Carolina Power & Light Company
PO Box 10429
Southport NC 28461

May 13, 1994

SERIAL: BSEP 94-0179
10 CFR 50.54(f)

BRUNSWICK STEAM ELECTRIC PLANT, UNIT NOS. 1 AND 2
DOCKET NOS. 50-325 & 50-324/LICENSE NOS. DPR-71 & DPR-62
RESPONSE TO REQUEST FOR ADDITIONAL INFORMATION REGARDING GENERIC LETTER 92-01,
"REACTOR VESSEL STRUCTURAL INTEGRITY, 10 CFR 50.54(f)" - REVISION 1

UNIT 1 SURVEILLANCE TESTING
WELD AND BASE METAL
CHARPY CURVES

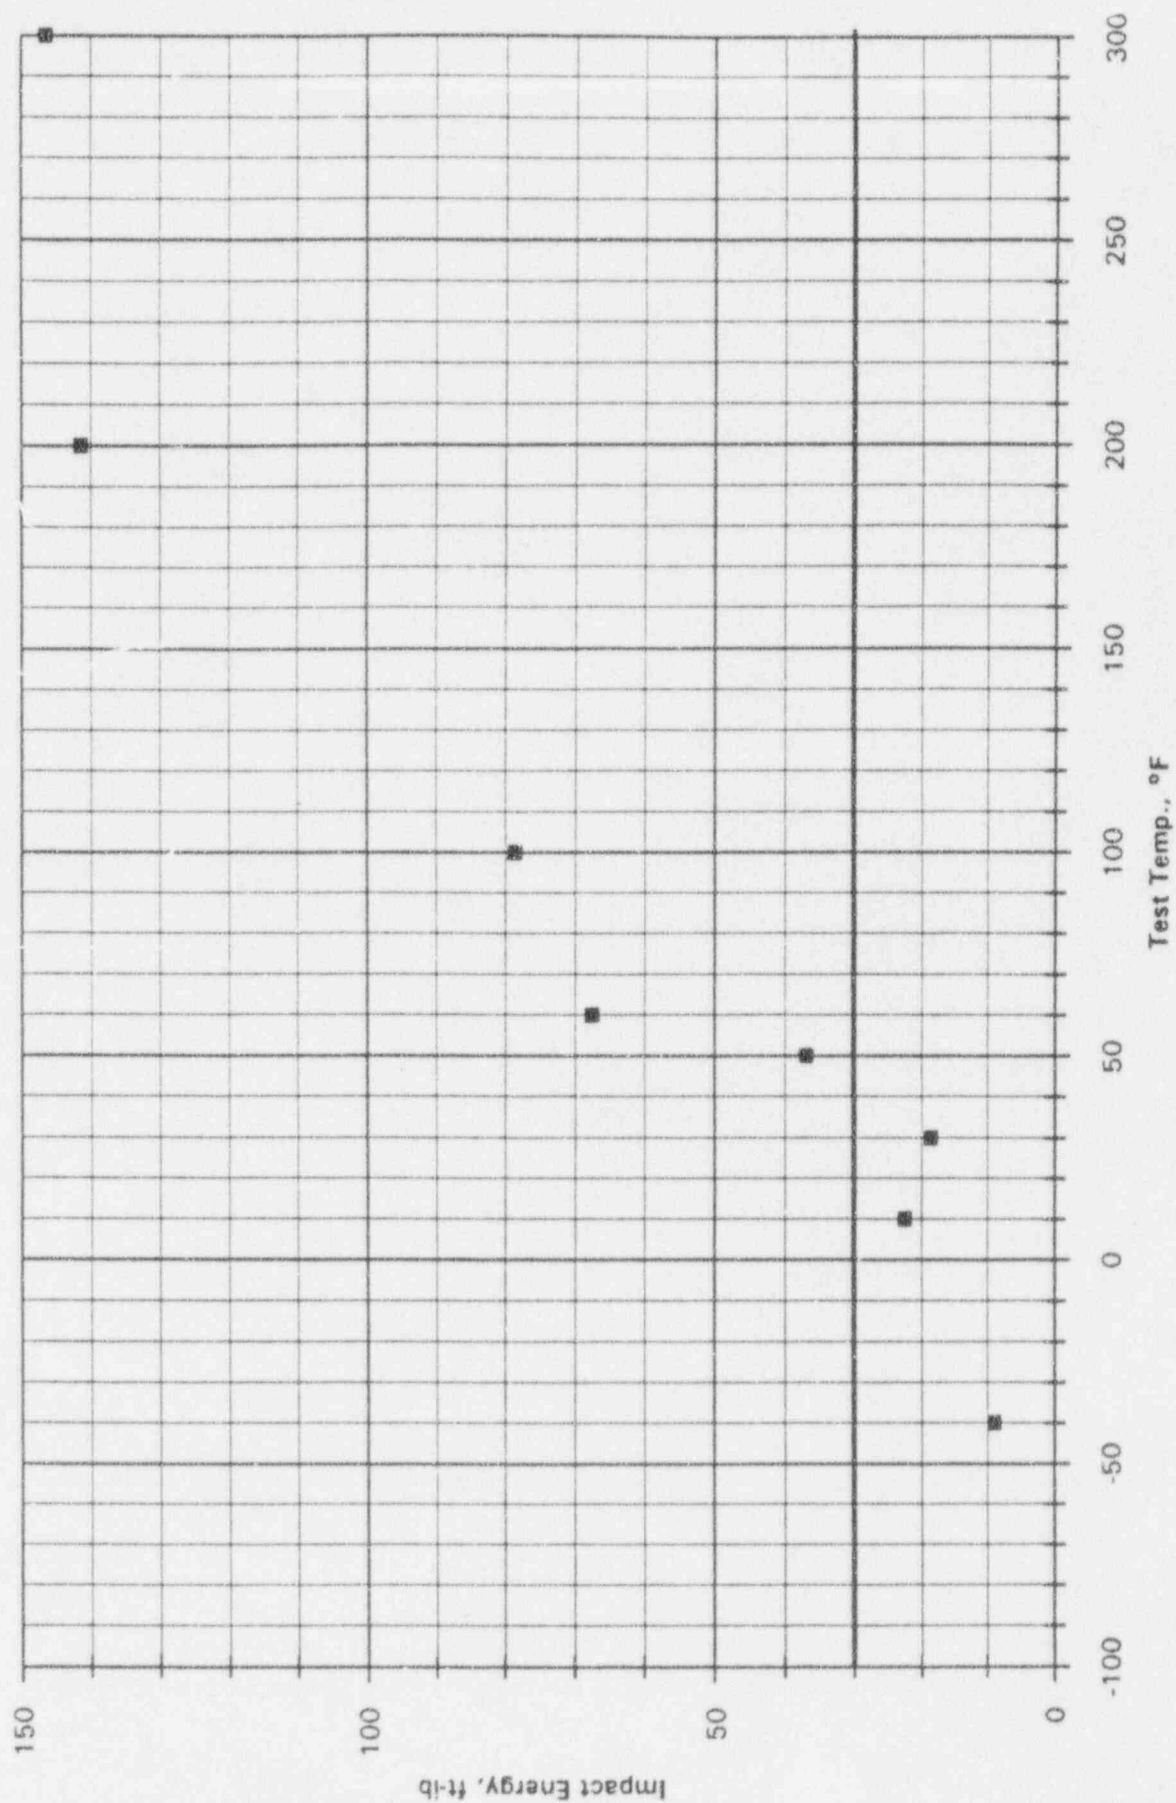
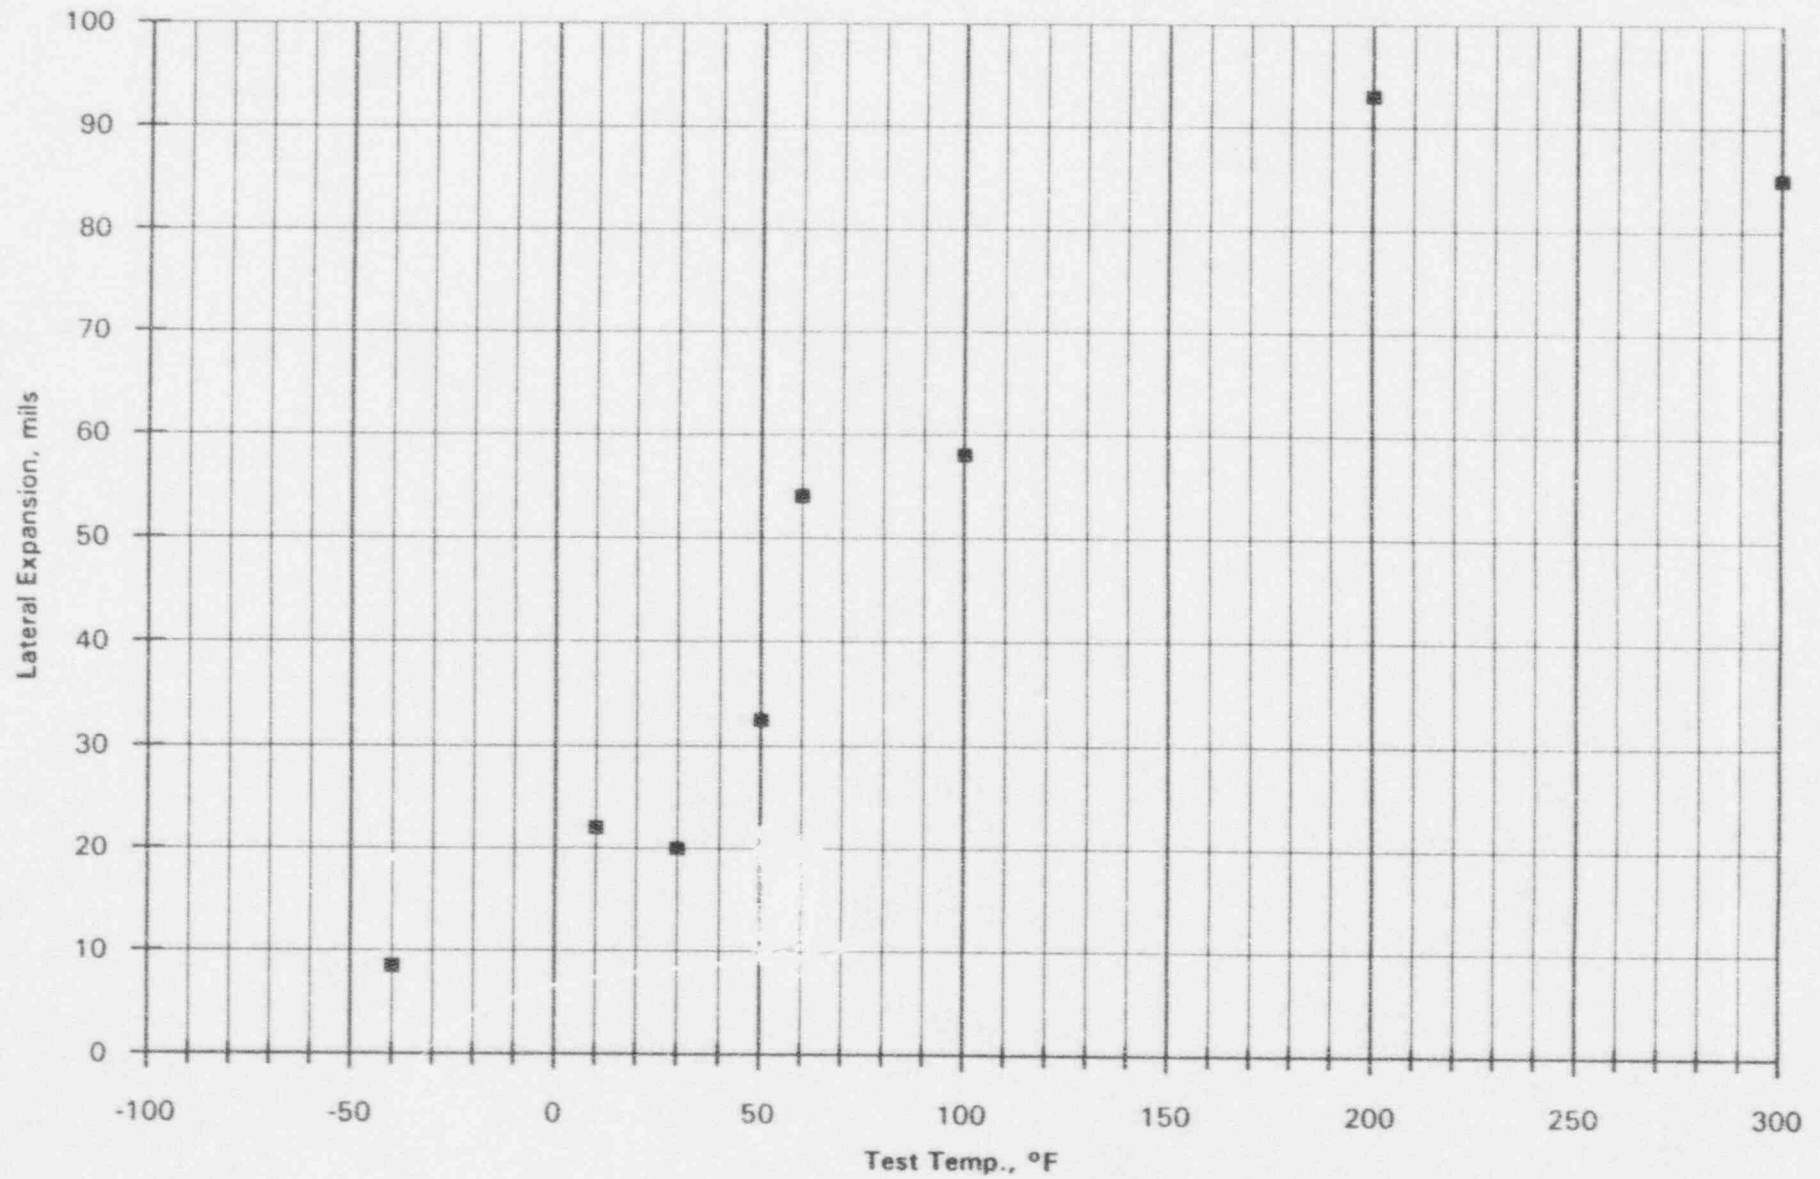
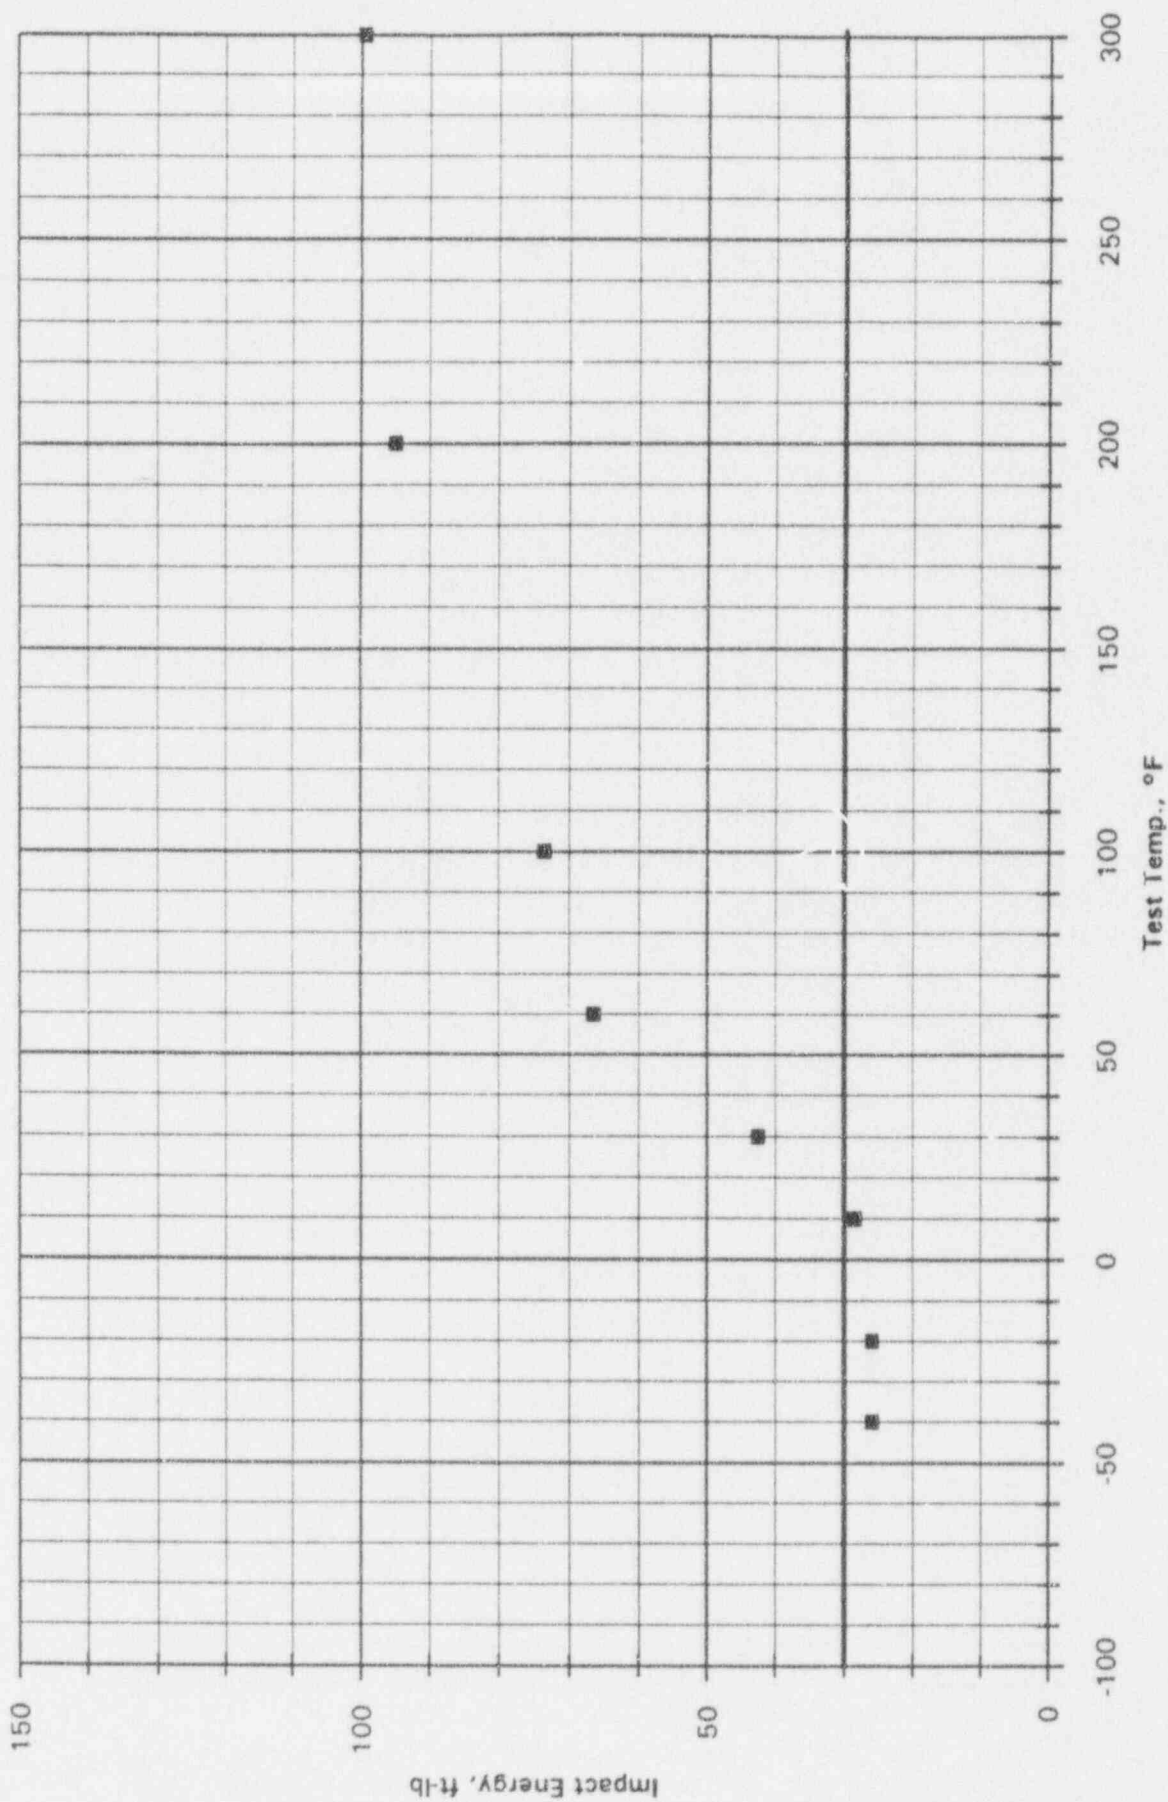
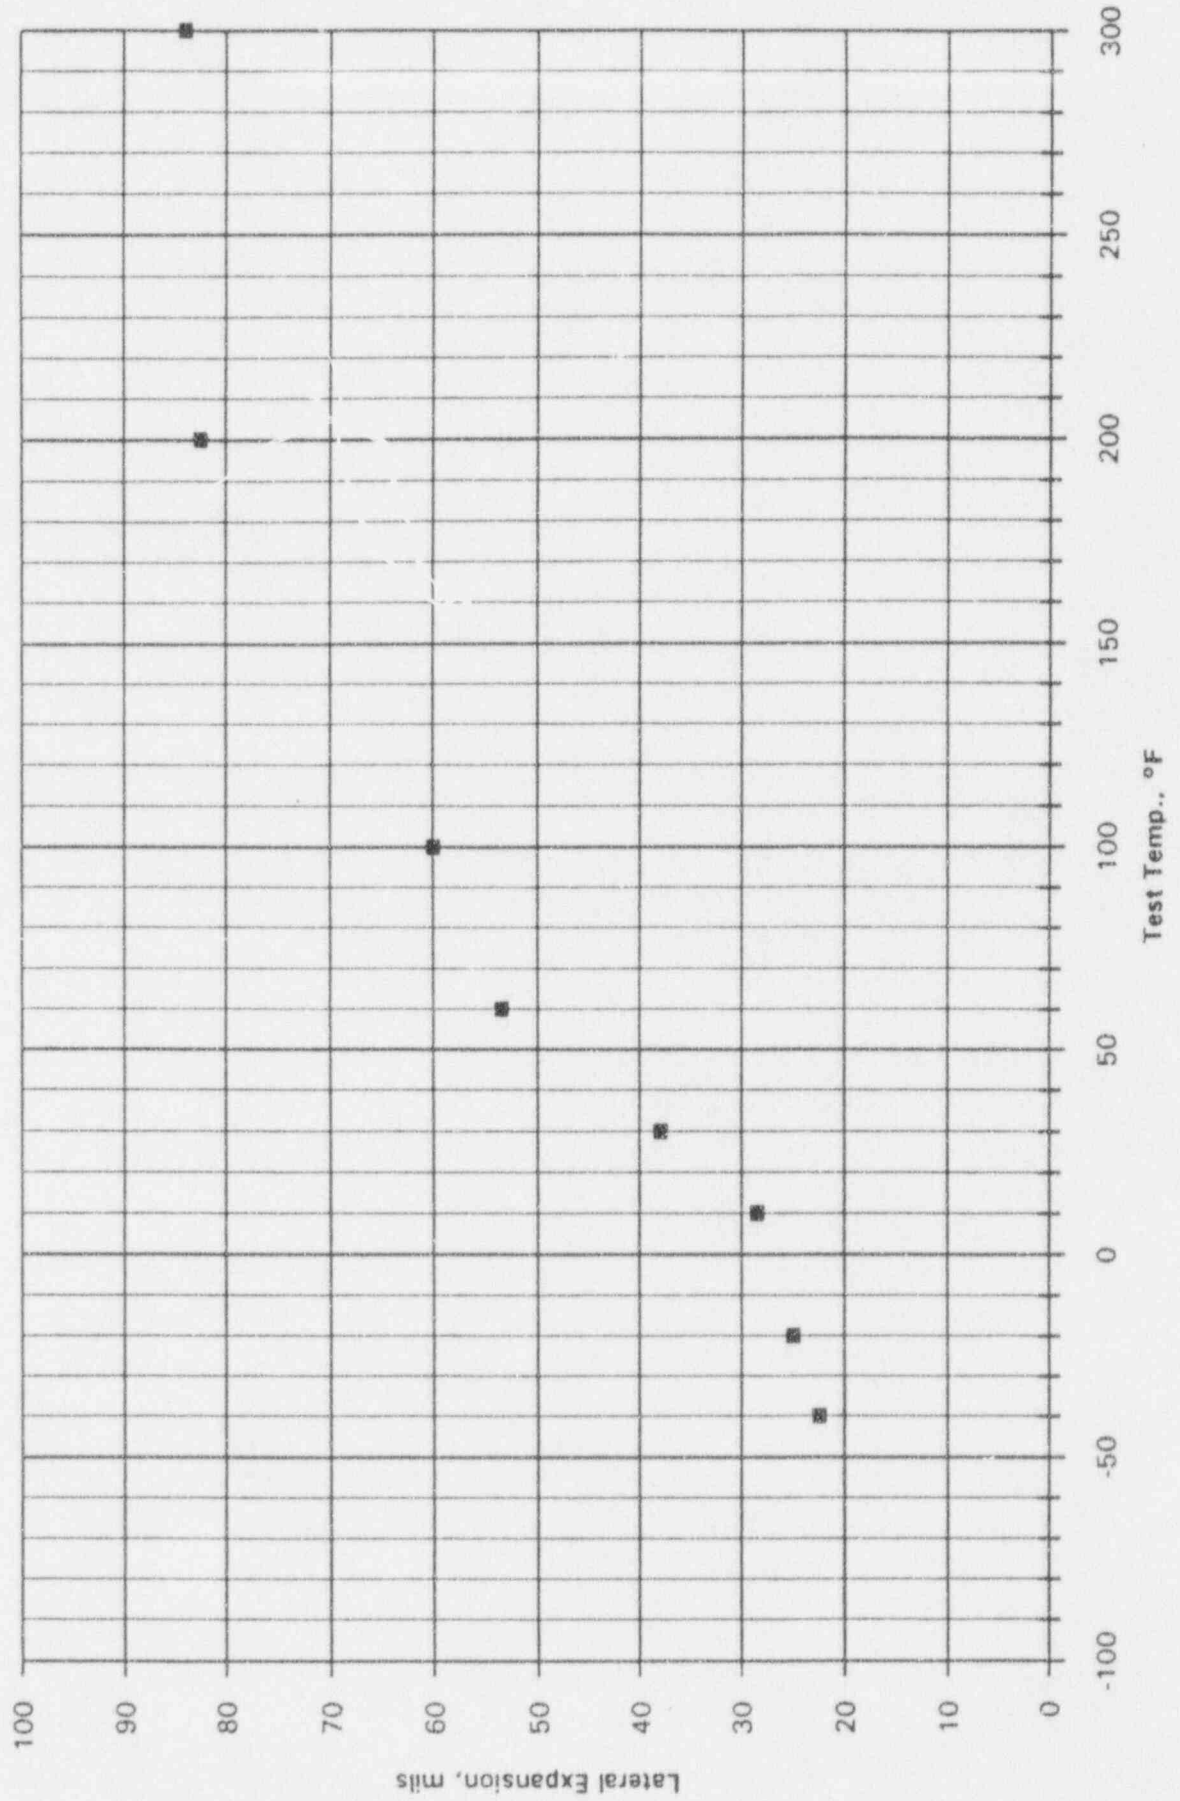
Surveillance tests have only recently been completed for Unit 1 at 8.7 Effective Full Power Years (EFPY); therefore, the surveillance report has not been finished (10CFR50 Appendix H report to be submitted to NRC by August 17, 1994). The Charpy curves, developed for weld and base metal (base metal Heat No. C4487-1) during these tests are attached for information (pages 12-18). Since the Unit 1 surveillance capsule dosimetry report is not complete, unverified dosimetry results have been used to make small changes in the fast neutron values used in the attached Appendix B pages (pages 8-11).
